CARD No. 44

Engineered Barriers

44.A.1 BACKGROUND

Calculation of linear feet of waste stack per panel

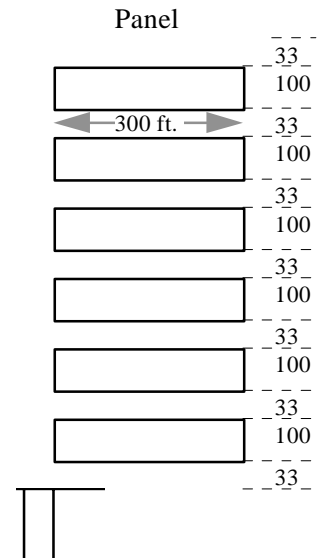
- Each Disposal Room is 33 feet wide and 300 feet long
- Each pillar is 100 feet wide
- Linear feet of Disposal Rooms/panel

$$\frac{300 \text{ feet}}{\text{Room}} \times 7 \text{ rooms} = \frac{2,100 \text{ feet}}{\text{panel}}$$
- Linear feet of Panel Access Drift

$$\left[\frac{33 \text{ feet}}{\text{room}} \times 7 \text{ rooms} + \frac{100 \text{ feet}}{\text{pillar}} \times 6 \text{ pillars} \right] \times 2 \text{ Drifts} =$$

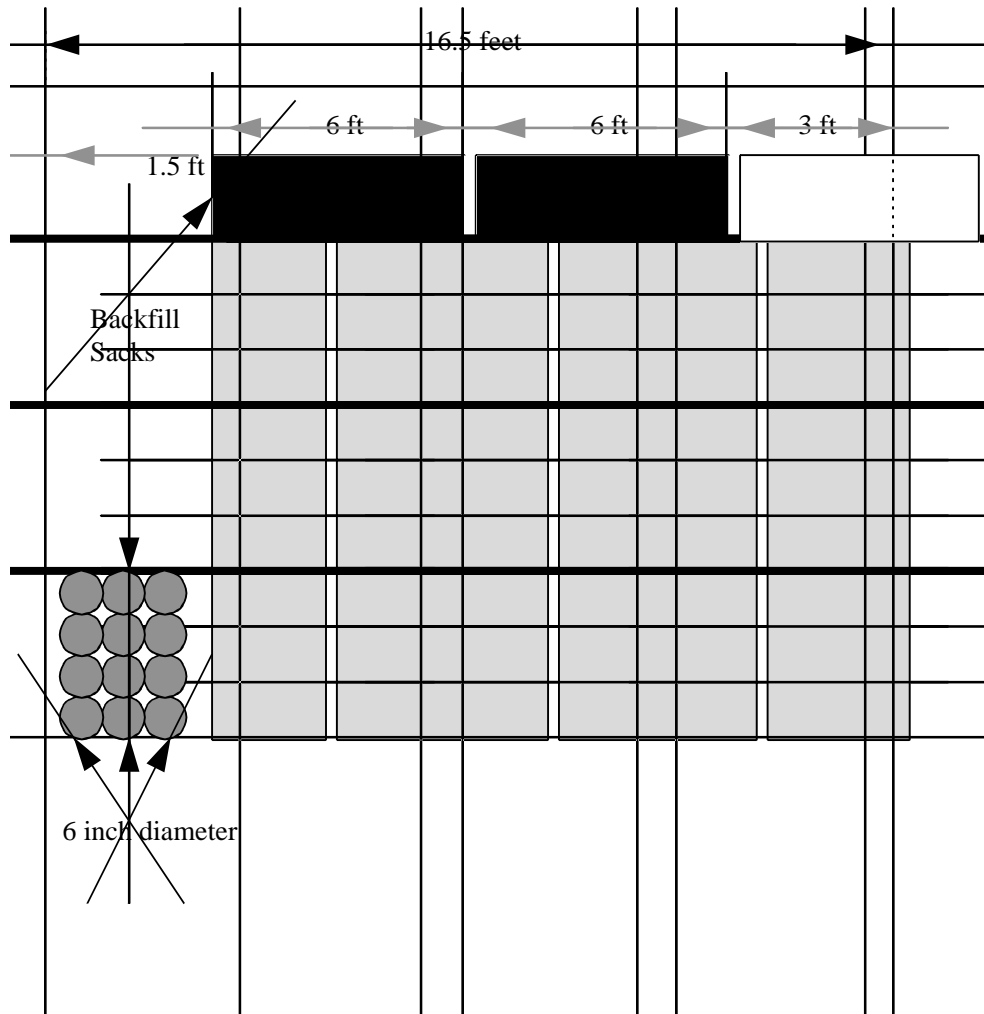
Weight of MgO in mini sacks = 25 lbs
There are 6 mini sacks per 7 pack of drums
There will be 12,000 7 packs per panel

$$25 \text{ lbs} \times 6 \times 12,000 = \frac{1,800,000 \text{ lbs of MgO}}{\text{Panel}}$$

$$\frac{1,800,000 \text{ lbs}}{2,000 \text{ lbs/tons}} = \frac{900 \text{ tons} \times 10}{\text{Panel}} = \mathbf{9,000 \text{ tons of MgO in Repository}}$$

DOE assumed $\frac{800 \text{ tons}}{\text{Panel}}$ or $\frac{8,000 \text{ tons}}{\text{Repository}}$
